VAUGHAN Staff Report Summary

File: A233/21

107 Lockheed Ave Maple Address:

Minor Variance Application

Dwg Title: Revision: SITE PLAN

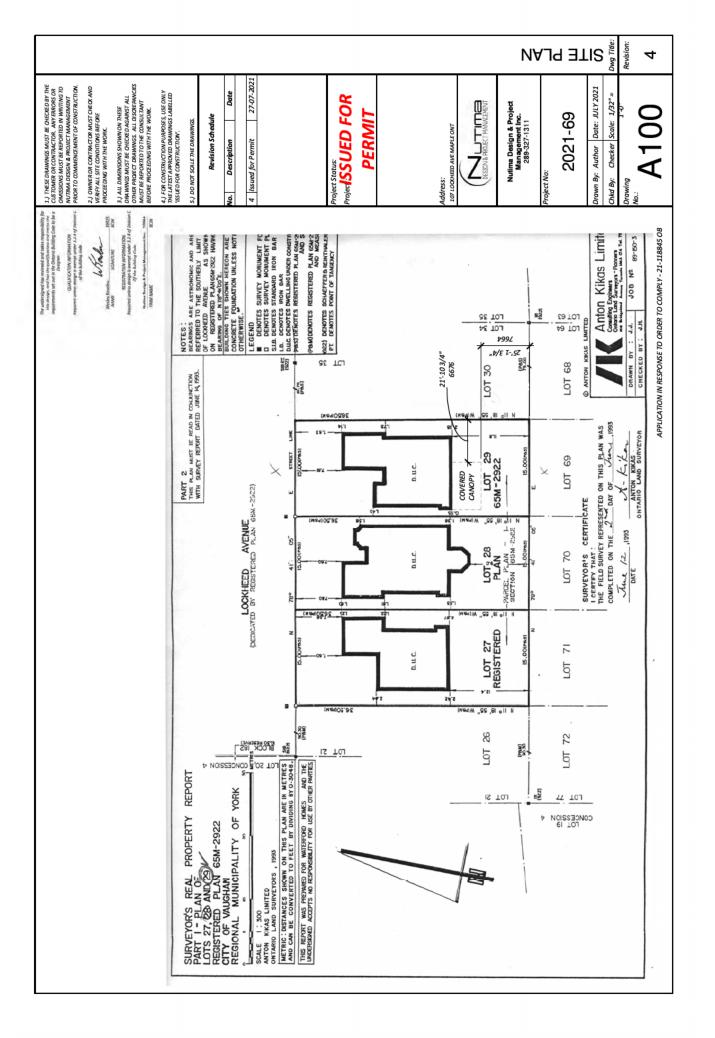
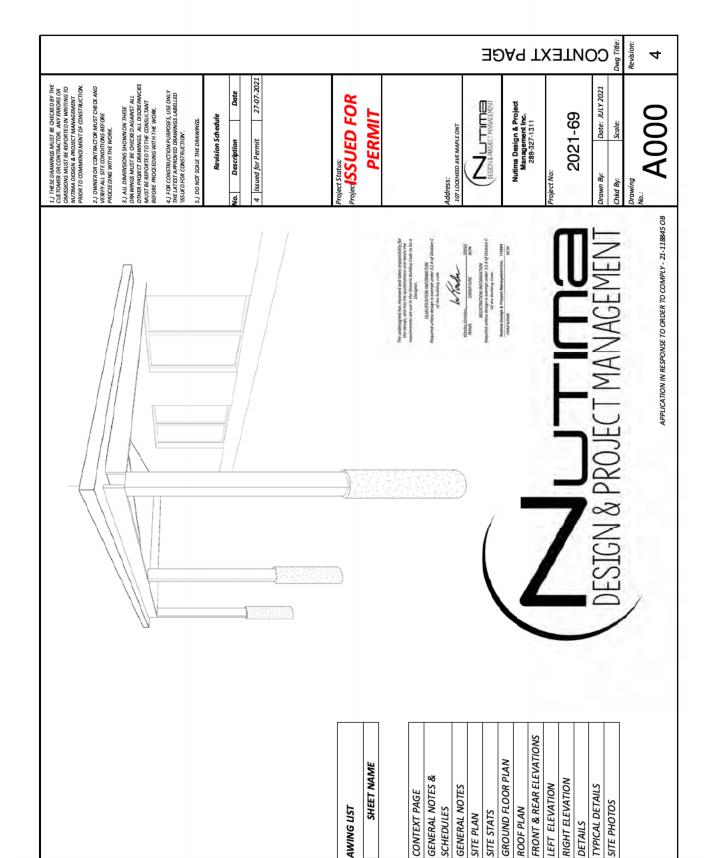
The neighborhood has received the notice for the construction of canopy. Your document indicates and existing concrete patio. On the contrary, it was installed simultaneously prior to canopy construction during the same period in 2021.

As for the canopy, we recommending to conform to the By-law requirement and decline the proposal to ensure the safety, sunlight and view of the adjacent neighbors.

The Development Planning Department has no objection to the variance, as the rear yard setback of 7.66 m does not pose a visual or drainage impact onto abutting properties, and the canopy is considered non-livable area and complies with the maximum height requirements of the By-law. Development Planning staff acknowledges that the interior side yard setback of 0.95 m is caused by the canopy remaining flush with a north-east corner of the dwelling that projects inward (closer to interior lot line), thereby, recognizing an existing deficiency.

The Development Planning Department recommends approval of the application.
